Form 3160-5 (June 2019)

1. Type of Well ✓ Oil Well Gas W	/ell Other		8. Well Name and No.	IGOR 33 FED COM/201H	
2. Name of Operator EOG RESOURC	CES INCORPORATED		9. API Well No. 30-02	25-49444	
	BY 2, HOUSTON, TX 77(3b. Phone No. (713) 651-700		10. Field and Pool or E

Change target formation to Second Bone Spring Sand.

Revised Permit Information 11/09/2023:

2314' FSL Revised Wellbore A: KB: 3708'

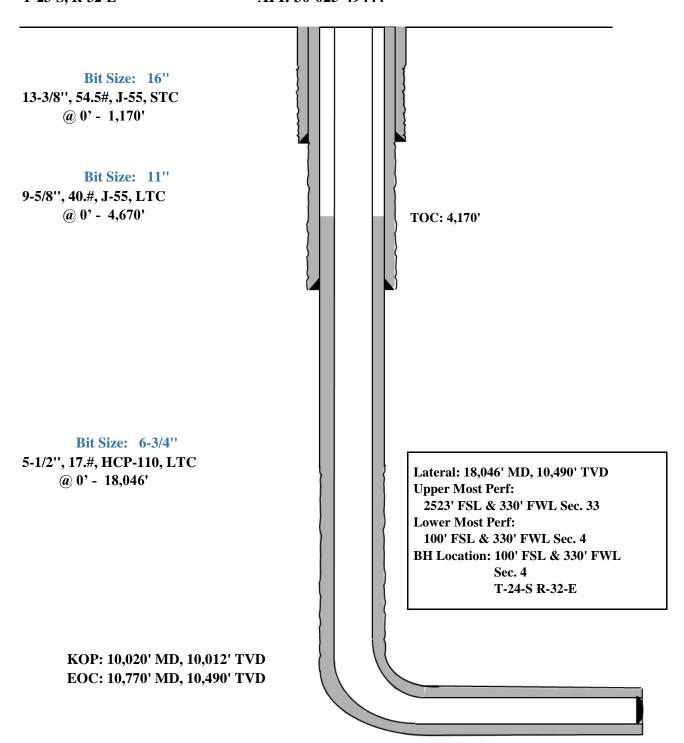
Casing Program A:

Hole	Interv	al MD	Interva	al TVD	Csg			
Size	From (ft)	To (ft)	From (ft)	To (ft)	OD	Weight	Grade	Conn
16"	0	1,170	0	1,170	13-3/8"	54.5#	J-55	STC
11"	0	4,682	0	4,670	9-5/8"	40#	J-55	LTC
6-3/4"	0	18,046	0	10,490	5-1/2"	17#	HCP-110	LTC

Variance is requested to waive the centralizer requirements for the 9-5/8" casing in the 11" hole size. An expansion additive will be utilized, in the cement slurry, for the entire length of the 11" hole interval to maximize cement bond and zonal isolation.

Variance is also requested to waive any centralizer requirements for the 5-1/2" casing in the 6-3/4" hole size. An expansion additive will be utilized, in the cement slurry, for the entire length of the 6-3/4" hole interval to maximize cement bond and zonal isolation.

EOG requests permission to allow deviation from the 0.422" annulus clearance requirement for the intermediate (salt) section from Onshore Order #2 under the following conditions:

2314' Revised Wellbore B: KB: 3708' 466' GL: 3683'

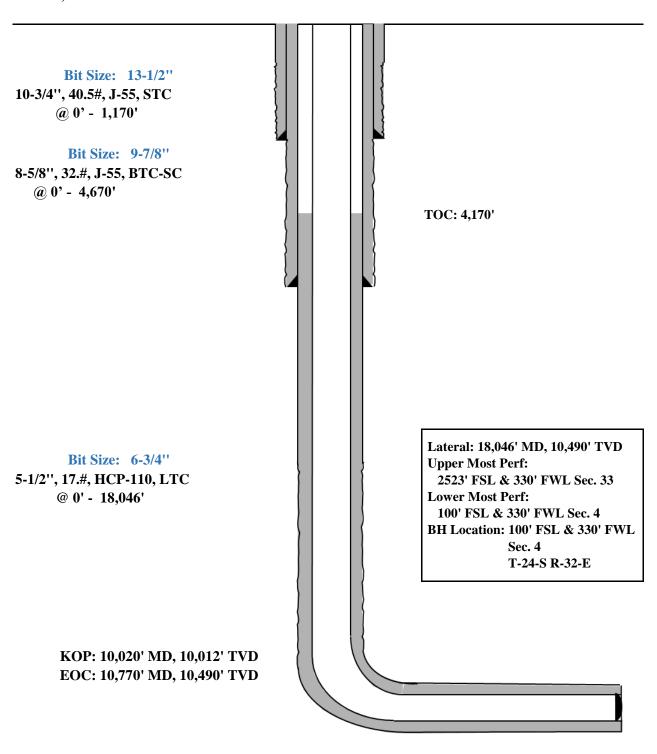
Casing Program B:

Hole	Interval MD		Interval TVD		Csg			
Size	From (ft)	To (ft)	From (ft)	To (ft)	OD	Weight	Grade	Conn
13-1/2"	0	1,170	0	1,170	10-3/4"	40.5#	J-55	STC
9-7/8"	0	4,682	0	4,670	8-5/8"	32#	J-55	BTC-SC
6-3/4"	0	18,046	0	10,490	5-1/2"	17#	HCP-110	LTC

Variance is requested to waive the centralizer requirements for the 8-5/8" casing in the 9-7/8" hole size. An expansion additive will be utilized, in the cement slurry, for the entire length of the 9-7/8" hole interval to maximize cement bond and zonal isolation.

Variance is also requested to waive any centralizer requirements for the 5-1/2" casing in the 6-3/4" hole size. An expansion additive will be utilized, in the cement slurry, for the entire length of the 6-3/4" hole interval to maximize cement bond and zonal isolation.

EOG requests permission to allow deviation from the 0.422" annulus clearance requirement for the intermediate (salt) section from Onshore Order #2 under the following conditions:

Design A

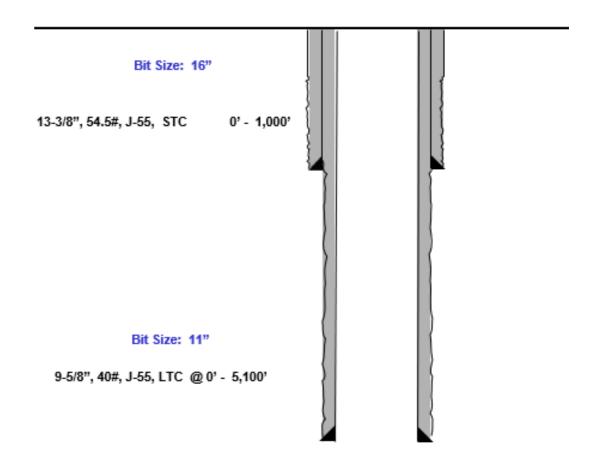
Proposed 11" Hole with 9.625" 40# J55/HCK55 LTC Casing

- 11" Bit + 0.52" Average hole enlargement = 11.52" Hole Size
 - 0.9475" Clearance to casing OD

$$=\frac{11.52-9.625}{2}$$

• 0.4475" Clearance to coupling OD

Proposed 9.875" Hole with 8.625" 32# J55/P110 BTC-SC Casing

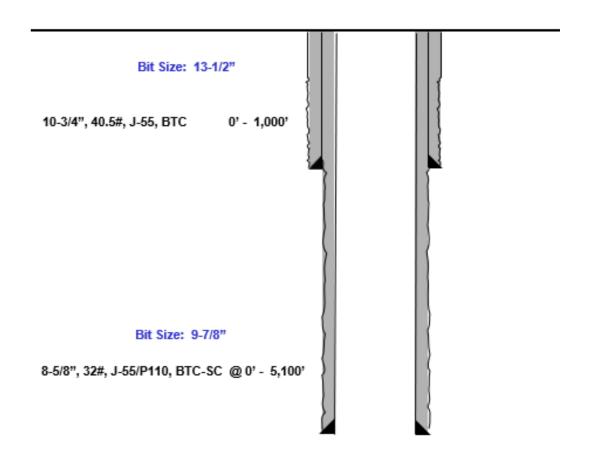
- 9.875" Bit + 0.42" Average hole enlargement = 10.295" Hole Size
 - 0.835" Clearance to casing OD

$$=\frac{10.295-8.625}{2}$$

• 0.585" Clearance to coupling OD
